October 17, 2006

Re: Response to Comments
Breckenridge Disposal Site, St. Louis, Michigan

ENVIRON International Corporation (ENVIRON), on behalf of the Custodial Trust provides the below responses to your October 2, 2006 comments to our September 19, 2006 Supplemental Site Characterization Work Plan. We have endeavored to address the NRC comments in a manor that is consistent with our discussions with NRC staff during our most recent June 22, 2006 meeting. Some of your comments raise questions on issues that we had understood to have been resolved. We hope that this response to comments letter will resolve the outstanding questions so that our Supplemental Site Characterization Field Work may proceed. In light of the fact that time is of the essence, should you not find our responses acceptable, we respectfully request that another meeting be convened with the NRC to affirmatively resolve any outstanding issues.

Figure 1: Dilution Factor Calculation

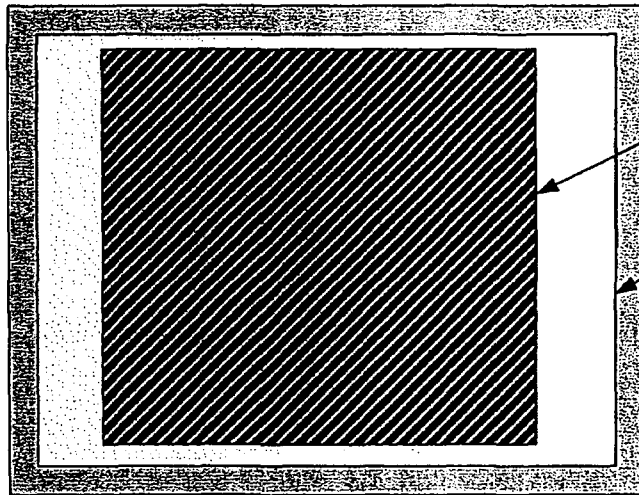
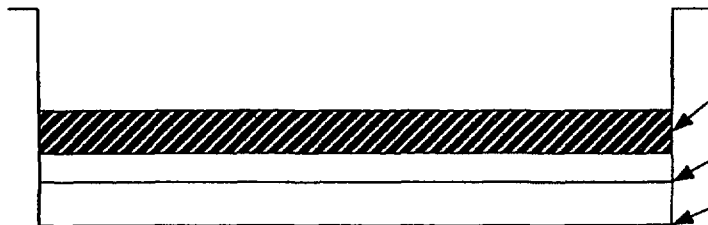
Comment 1. Please confirm that the subsurface soil with subsurface DCGL, when brought to the surface, will not exceed the surface DCGL. In other words, the subsurface DCGL should be less than surface DCGL times dilution factor (Contaminated soil mixed with nearby clean soil when brought to the surface).

Response: As discussed in ENVIRON's August 3, 2006 letter, a reasonable scenario in which material would be brought to the surface is a construction of a house with a basement. It is reasonable to assume that that during excavation, the soil is thoroughly mixed and the resulting concentration is equal to the average activity level of the soil volume excavated. This mixing can be calculated by developing a dilution factor. The following equation will be used to calculate the dilution factor.

The calculation of the volume is shown on Figure 1. The calculated dilution factor is 9.1. As shown in Table 1, the subsurface 2006 DCGLs are protective of human health even if brought to the surface.
